26 October 2018

COMMENTS ON THE DRAFT INTEGRATED RESOURCE PLAN 2018

Figure 1: Electricity emissions within total SA emissions of 212 Mt CO₂e in 2050

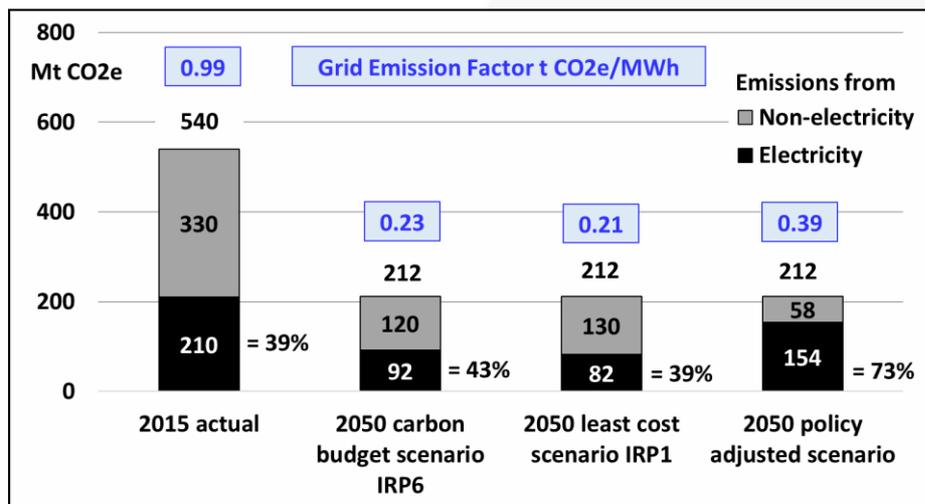
This means that the recommended plan (policy adjusted IRP) allocates 73% of the carbon space available within the lower limit of the projected NDC to the electricity sector. Consequently, non-electricity sectors are left with only 27% of the carbon space by 2050, which would require a reduction from current emission levels of 82%.

This is concerning for the impacted industrial sectors. Technology price reductions for the electricity sector have reduced as has been acknowledged by the introduction of the least cost pathway but it appears that the sector is not maximising the opportunity that we are presented.

BUSA believes that it is imperative to have a comprehensive discussion on this aspect of the IRP before finalisation. Essentially the IRP is not only an electricity plan but a greenhouse gas emissions reduction plan for the electricity sector, and accordingly cannot be seen in isolation of other emitting sectors of the economy.
